CMB Meeting Minutes #176

SUBJECT: Configuration Management Board Meeting # 176 – Rev. No. 0

Project No. M544.1, Contract No. CS-149
Program/Construction Management
Configuration Management Board (CMB) Meeting No. 176
July 02, 2014
3:00pm – 5:00pm
Central Subway Project Office
821 Howard St. 2nd Floor
Main Conference Room

CHANGE ORDER REQUEST NUMBER 070**SFMTA Contract No. 1252**
CENTRAL-SUBWAY-TUNNELING**Contractor:** Barnard Impregilo Healy JV
420 Fourth Street
San Francisco, CA 94107**SUMMARY RECORD OF NEGOTIATIONS****SCOPE OF WORK:**

Field Sketch No. FS 1252 - 042
COR 070
Contract Modification No. xx

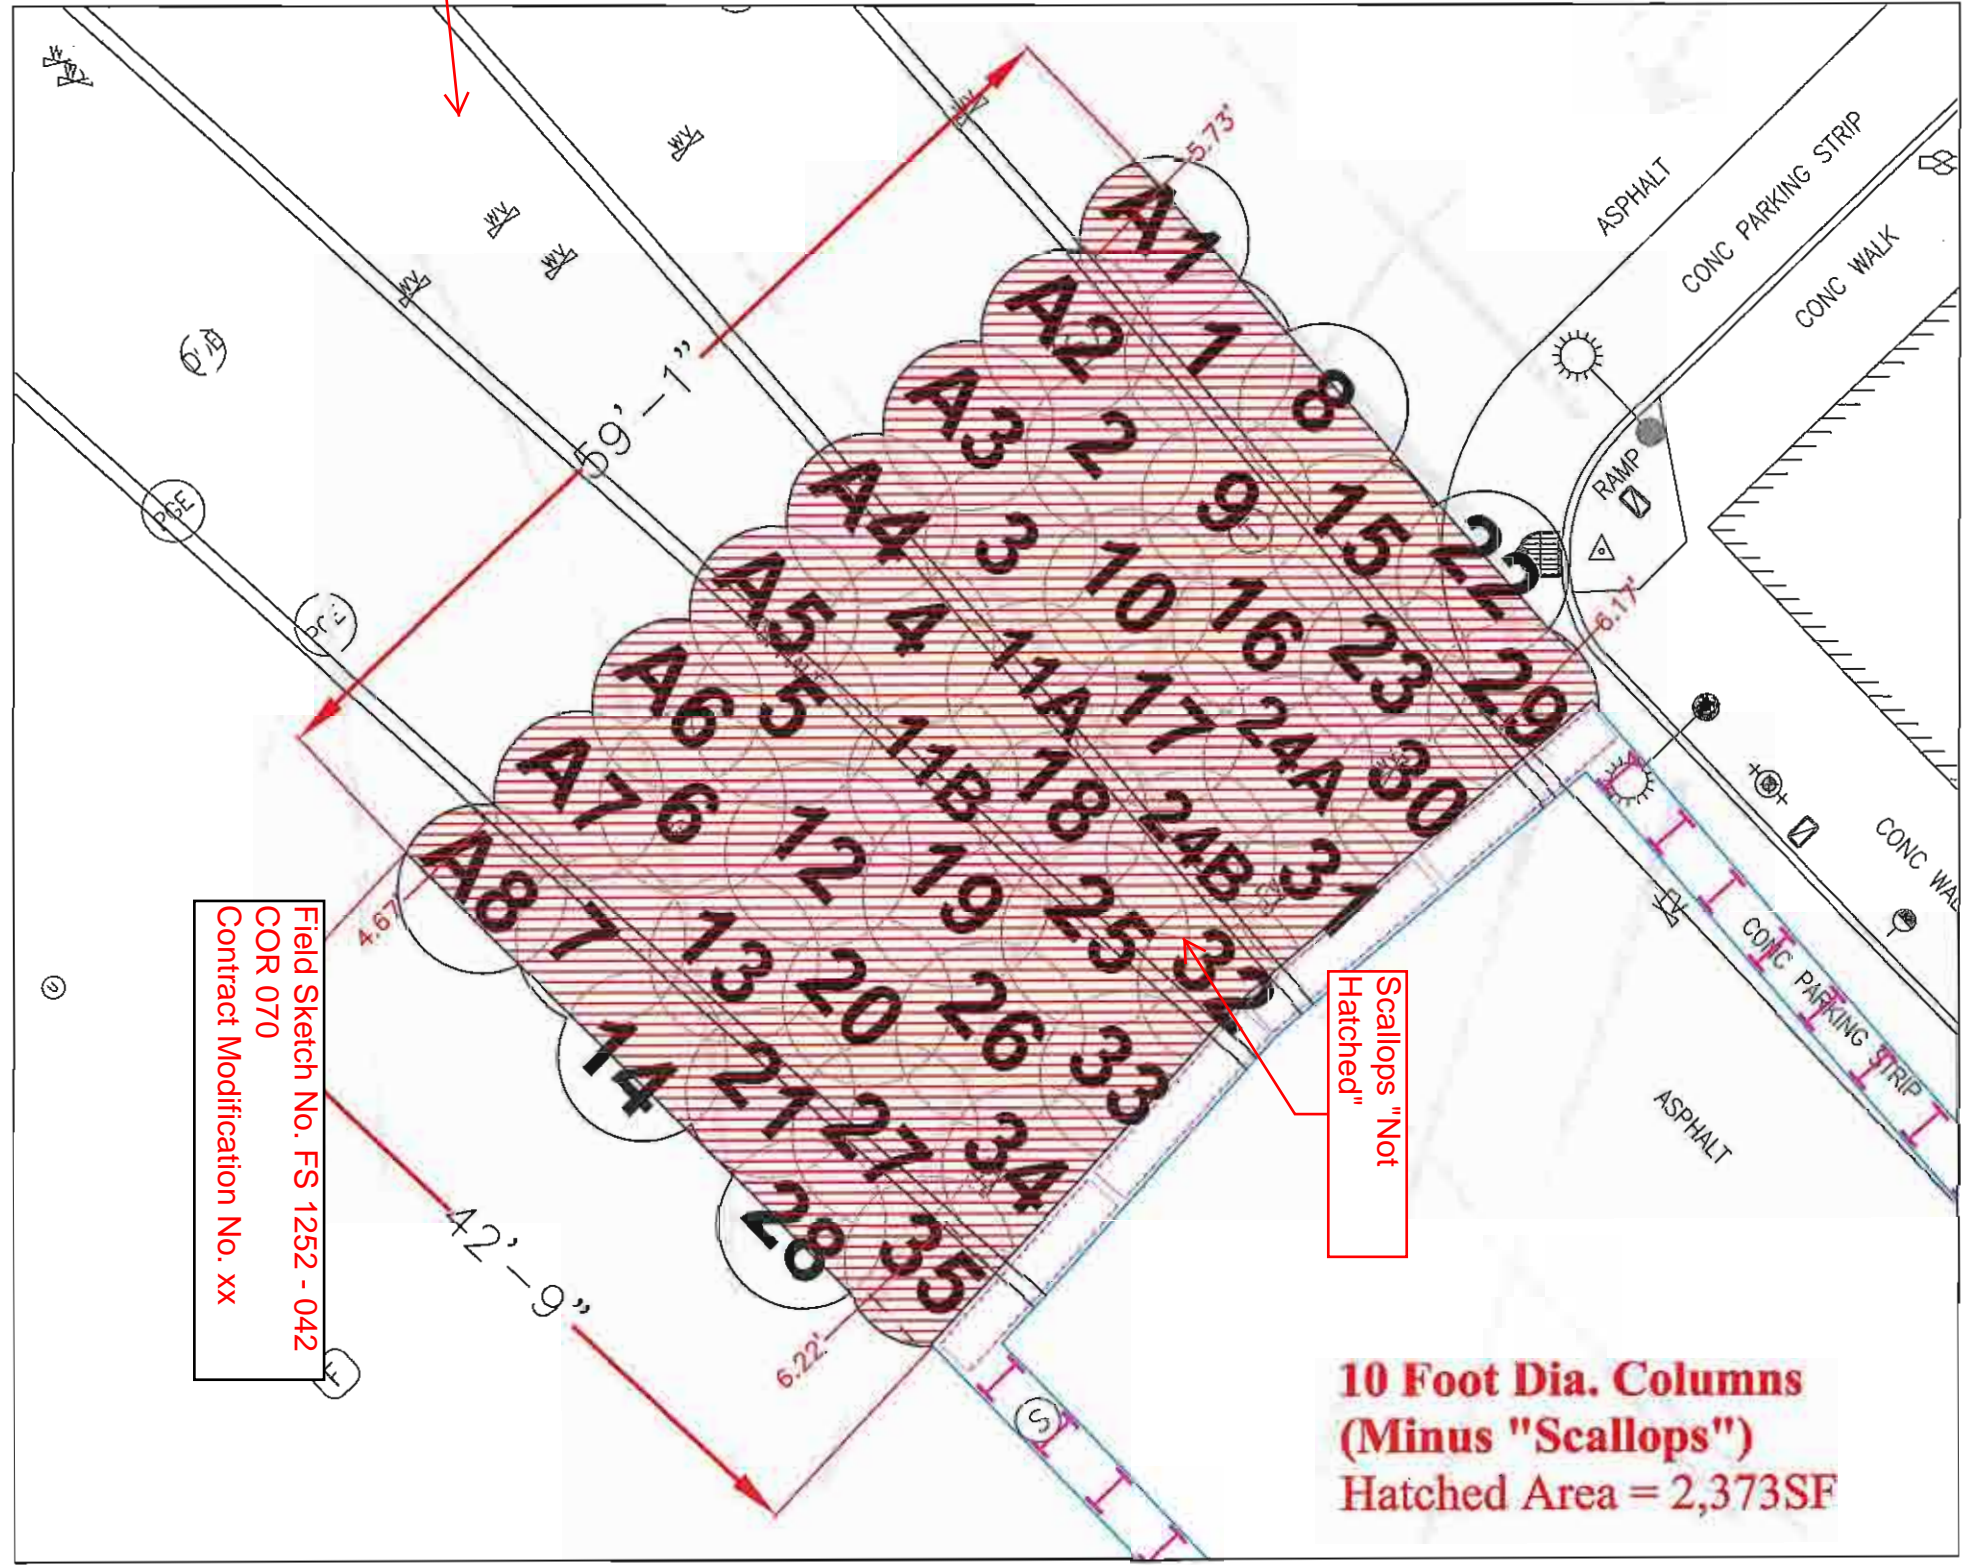
Scallops "Not
Hatched"

**10 Foot Dia. Columns
(Minus "Scallops")
Hatched Area = 2,373SF**

Field Sketch No. FS 1252 - 043
COR 070
Contract Modification No. xx

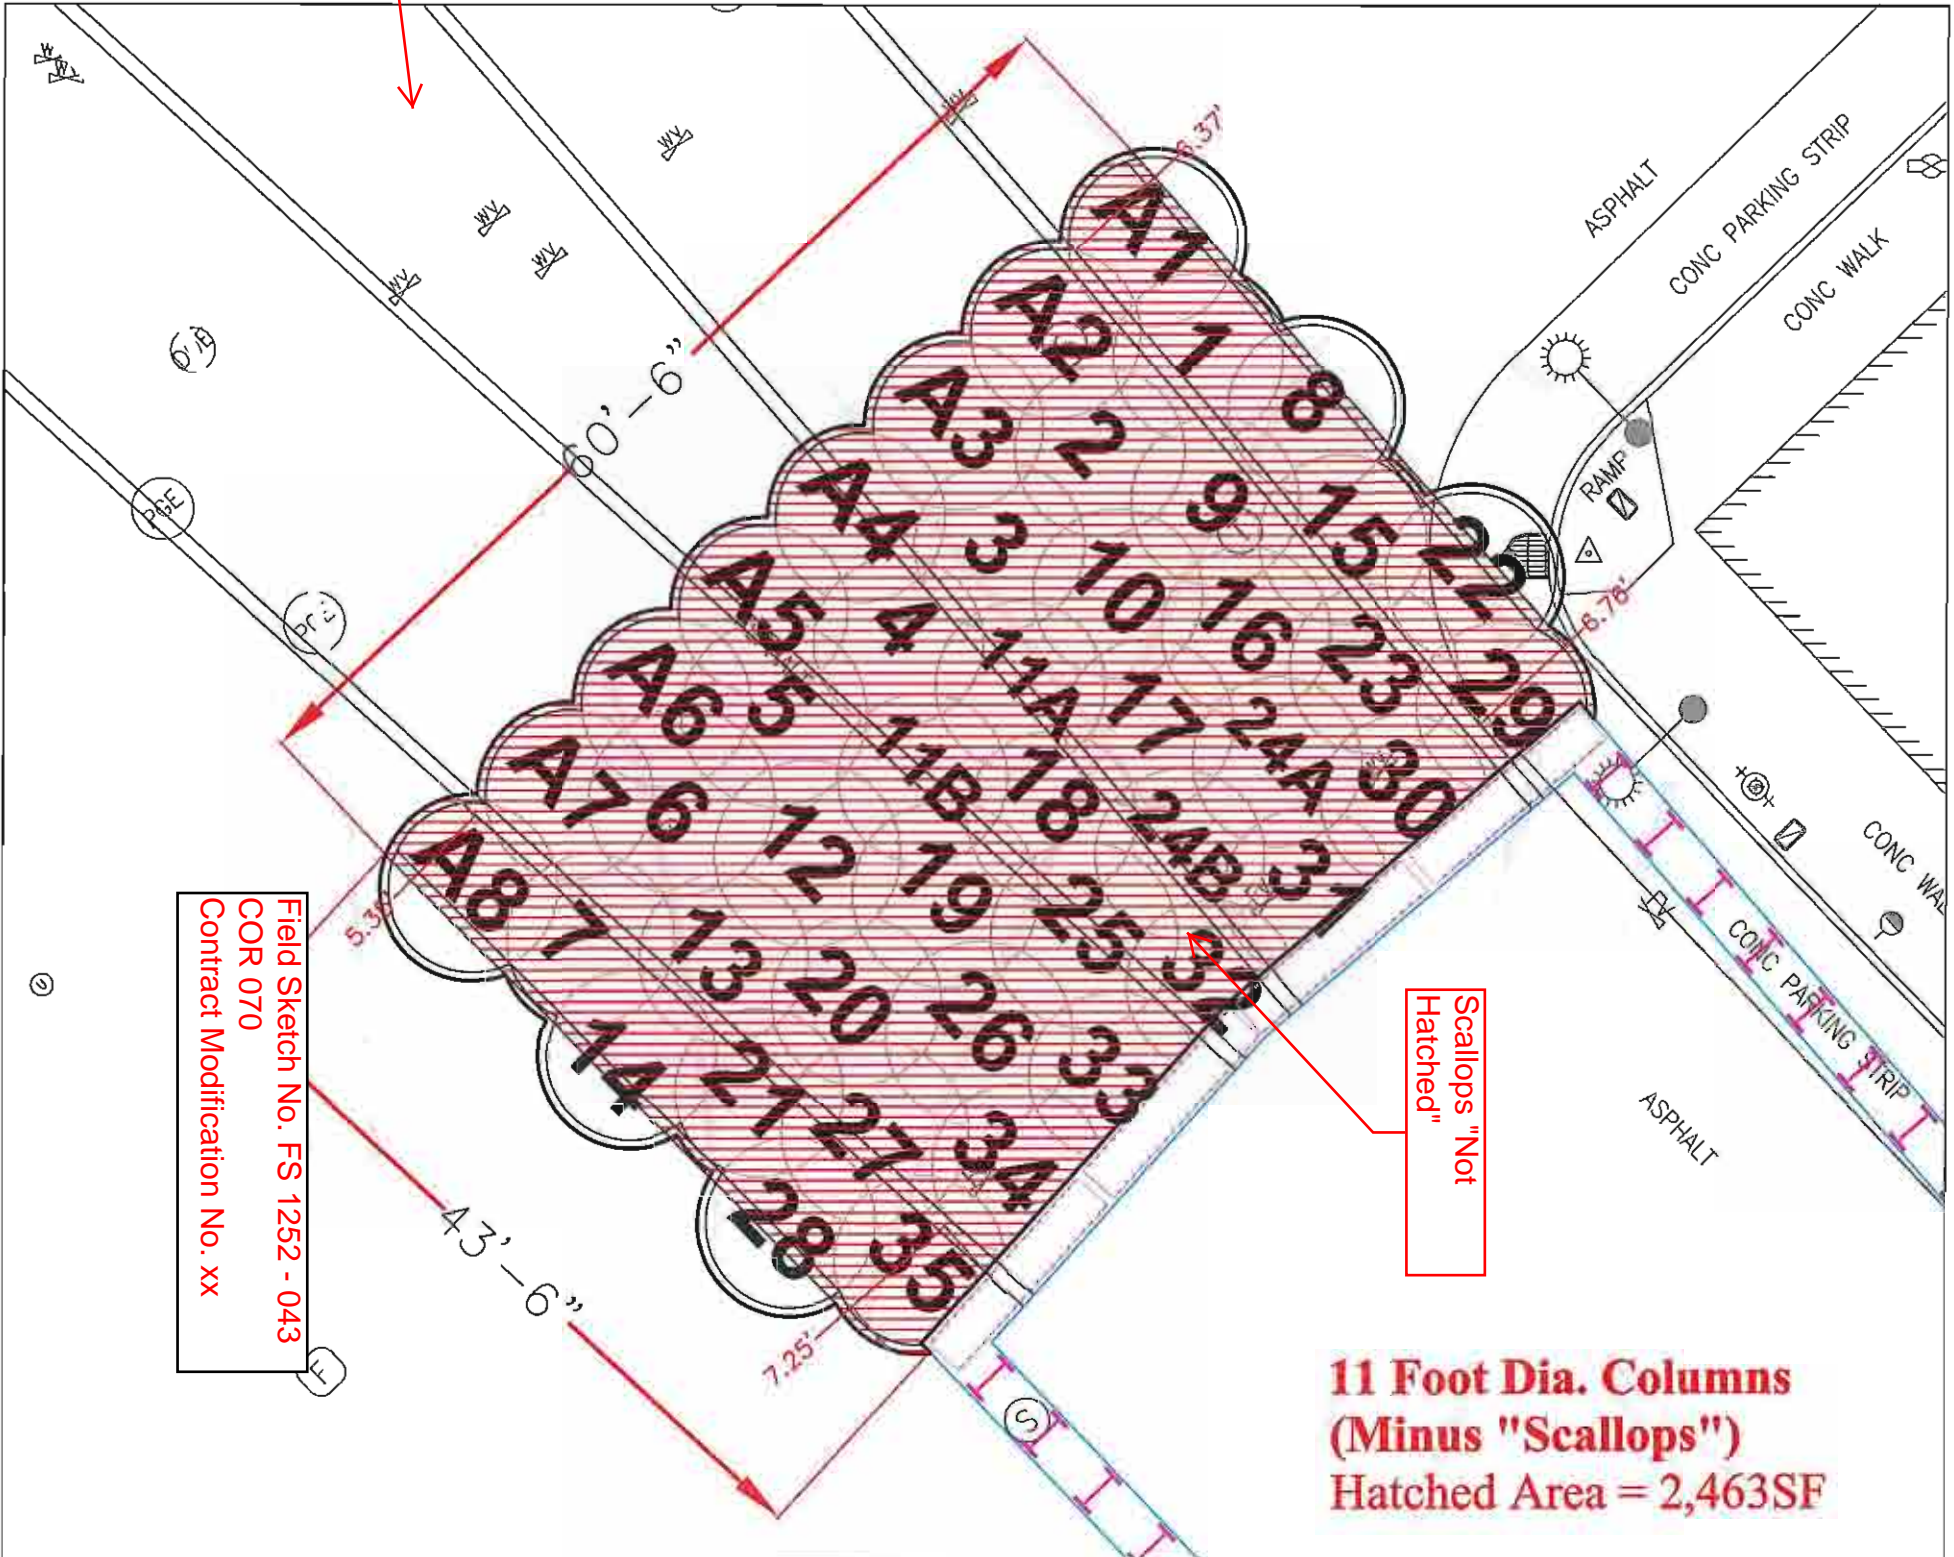
Scallops "Not
Hatched"

**11 Foot Dia. Columns
(Minus "Scallops")
Hatched Area = 2,463SF**
